# POST OCCUPANCY EVALUATION

## PAPAMOA COLLEGE PAPAMOA, TAURANGA

June 2016

Date: June 2016  
Reference: 1-46083.00  
Status: FINAL

Figure 7

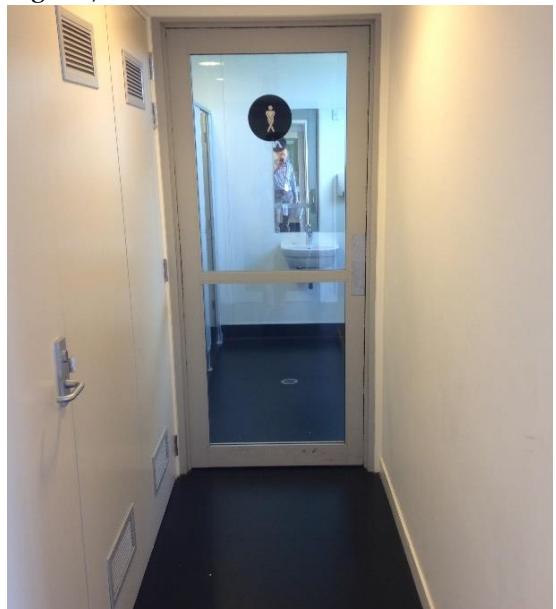
- Staff report that due to insufficient allowance for storage within the design, some unused accessible bathrooms are being used for storage of equipment. See Figure 7.

- There are no emergency call buttons within the accessible toilets, and oversight into these spaces is minimal for passers-by. See Figure 7.
- Whilst not a requirement of the MoE guidelines at the time, there are no power outlets within the accessible bathrooms to allow for the potential need for hoist facilities in the future.

Figure 13

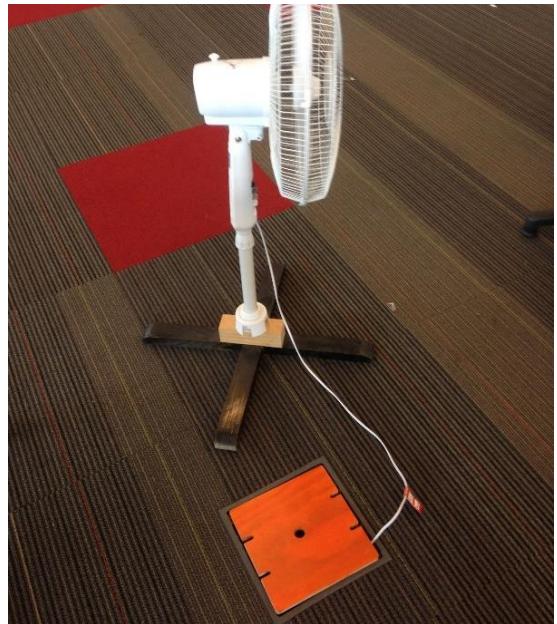
- Free standing, temporary fans have been added to learning spaces to assist with air circulation, as users felt the level of ventilation provided by the passive ventilation was insufficient. The users do not like having these fans as they are noisy and their power cords present a trip hazard. See Figure 13.

- Staff advise that the floor box covers to power points within learn spaces were not robust enough and a number were damaged through general use, presenting trip hazards. The covers to these have been replaced with more robust, plywood covers at the college's expense. See Figure 13.

Figure 23

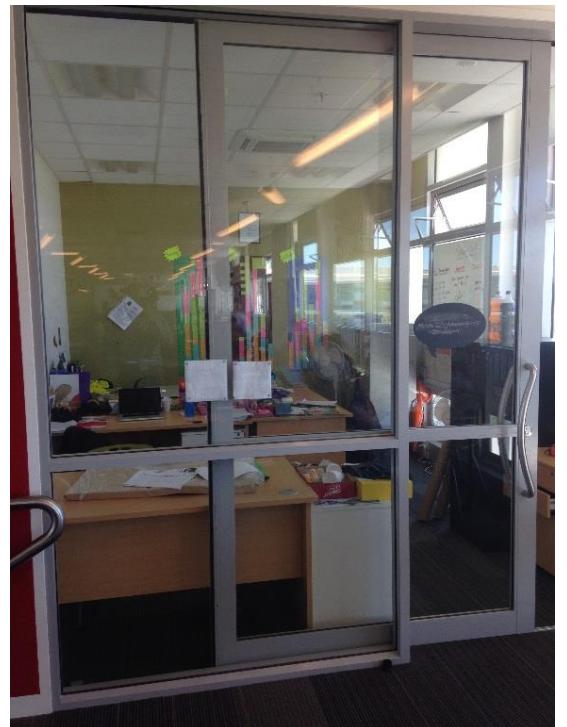
- Staff use the designated break out spaces within the learning areas as teacher work spaces. The Principal reported that that it was originally intended that teachers should be based and work in the main teaching spaces at all times, but this did not work for staff. As a result of the alternative use of the breakout rooms, there are no quiet areas (breakout spaces) available in the teaching spaces for individual or small student group lessons, confidential talks or counselling sessions. See Figure 23 of one of the breakout spaces adapted as teacher work space.
